Type 1A4

PRODUCT MODIFICATION INDEX

ADD-MODE OSCILLATION PREVENTED

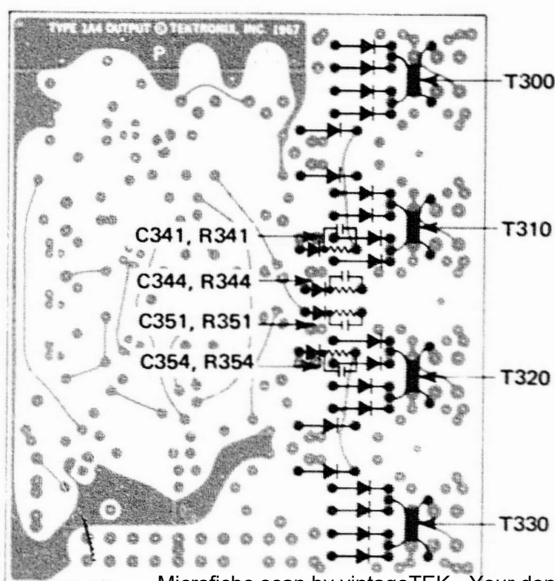
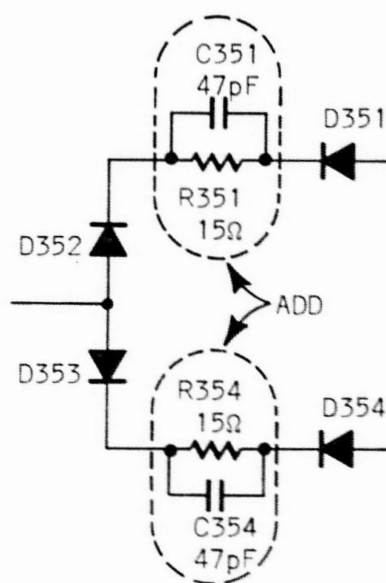
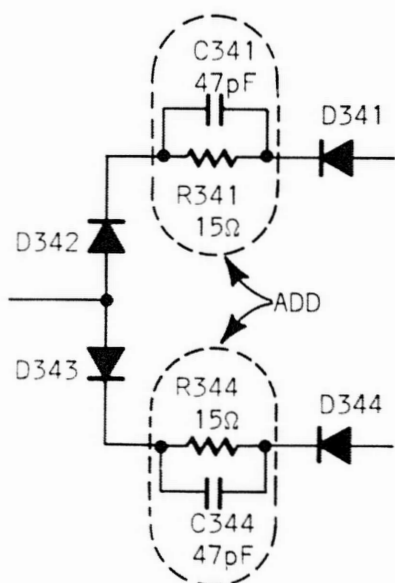
Oscillations could occur when using the VARIABLE VOLTS/CM control with all four channels in the ADD-MODE.

To prevent this, T300, T310, T320 and T330 were changed and four RC networks were added to the Output Amp board.

Refer to the drawing and modify the Output Amp board as follows:

- Change T300, T310, T320, and T330 from 120-0482-00 to 120-0269-00.
- Add C341/R341, C344/R344, C351/R351, and C354/R354, 47pF/15Ω networks to the cathode circuits of D341, D344, D351 and D354 respectively. Follow mounting detail carefully.

OUTPUT CIRCUIT BOARD LAYOUT CHANGED

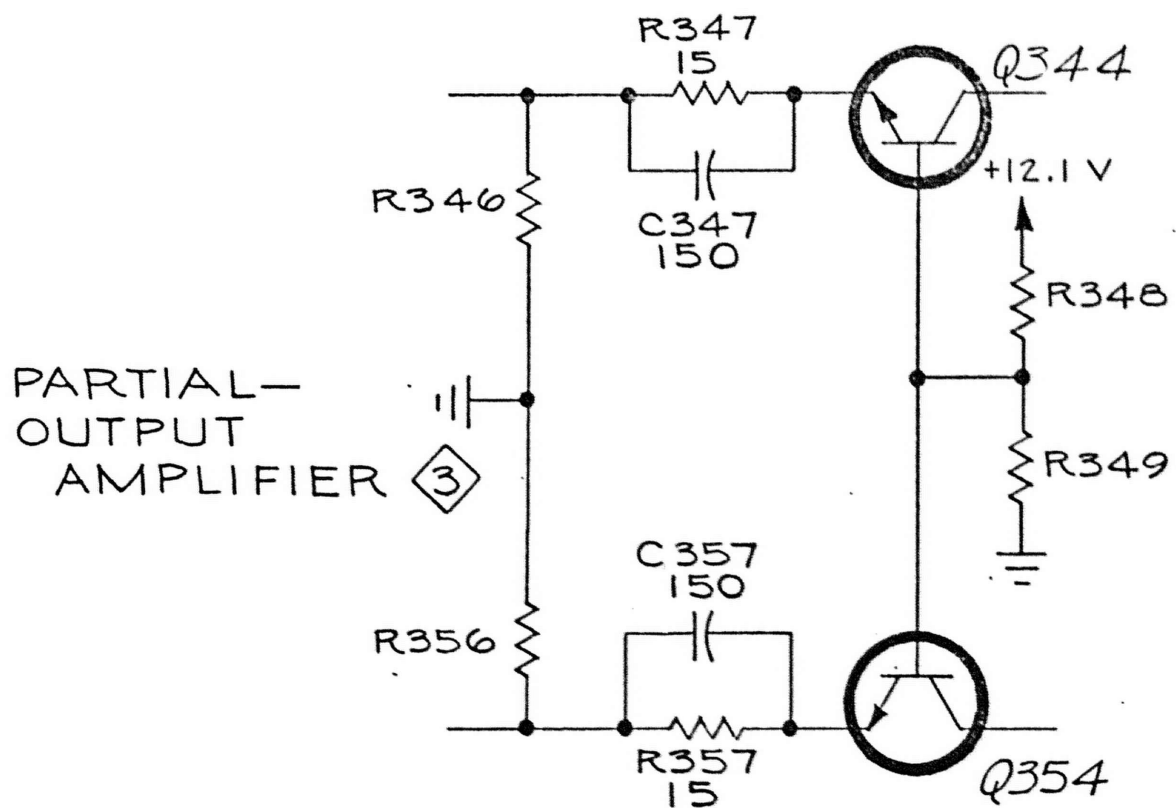
The Output circuit board layout was changed to accommodate components added by Mod 16802. Due to new layout, all of the components added by Mod 16802 are not needed. Previous layout of components and connecting points required adding (4) 47pF capacitors and (4) 15 Ω resistors to eliminate oscillation. The new layout requires only (2) 150pF capacitors and (2) 15 Ω resistors.
